UNITED STATES PATENT AND TRADEMARK OFFICE

| APPLICATION NO. | FILING DATE | FIRST NAMED INVENTOR | ATTORNEY DOCKET NO. | CONFIRMATION NO. |
|---|-------------|----------------------|---------------------|------------------|
| 10/813,228 | 03/31/2004 | Charles E. Benedict | 14630 | 3874 |

| Office Action Summary | Application No. | Applicant(s) |

DETAILED ACTION

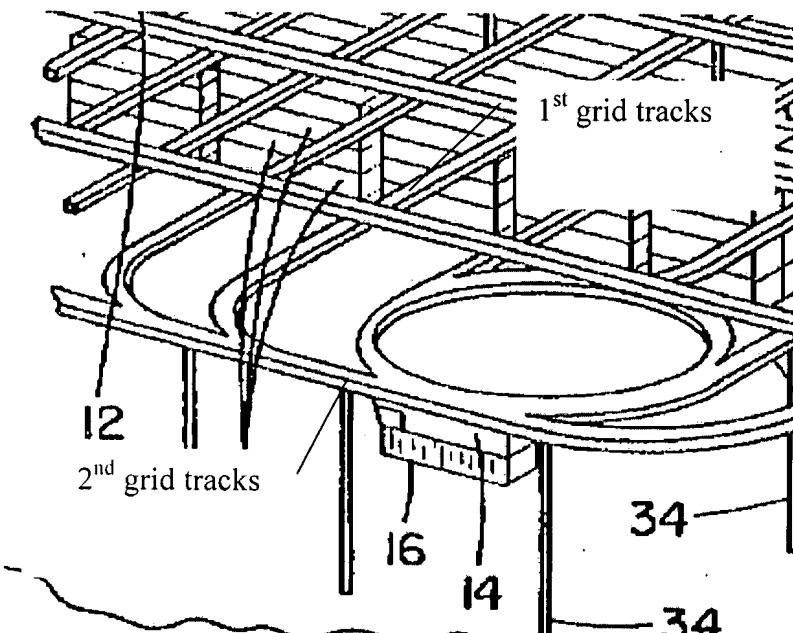
Claims 1, 7, 9, 12, 18 & 24 are rejected under 35 U.S.C. 102(b) as being anticipated by Brickner et al. (US 4,973,219) (previously cited).

With respect to claims 1 & 24, Brickner et al. disclose-

- vertical cells structure 12, 34, 36
- tier levels, e.g. stacked containers 16
- grid track system 12 above vertical cells
- grid first tracks intersecting with second grid tracks (see FIG. 1 reproduced below)
- transfer unit 14 suspended from a grid track system
- a plurality of carriage means (indicated generally as 44) suspending a transfer unit

- transfer unit drive means 54
- spreader beam 40
- hoist means 55
- guide member 42
- means (C18/L30-45) for providing electrical power to a drive means.

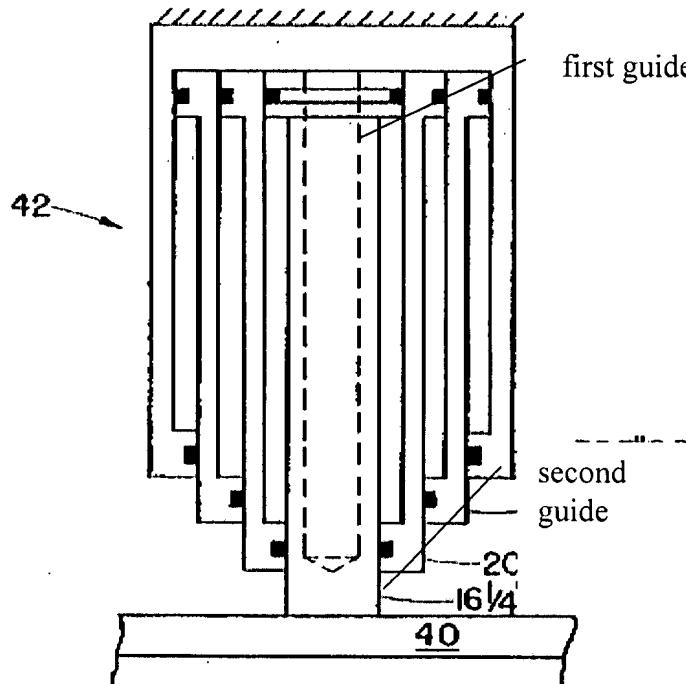
With respect to claims 7 & 18, Brickner et al. disclose a first guide member mounted to a transfer unit and a second guide member mounted to a spreader beam 40 said guide member comprising arms. See FIG. 9 reproduced below.

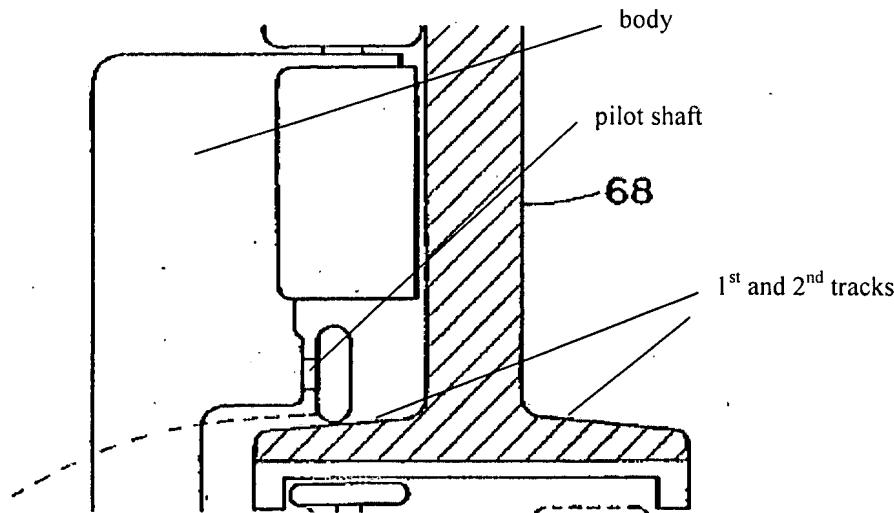
With respect to claims 6 & 13, Brickner et al. discloses rollers 44 mounted to a body, each body received within a channel 68, pilot shaft. See FIG. 8 reproduced below.
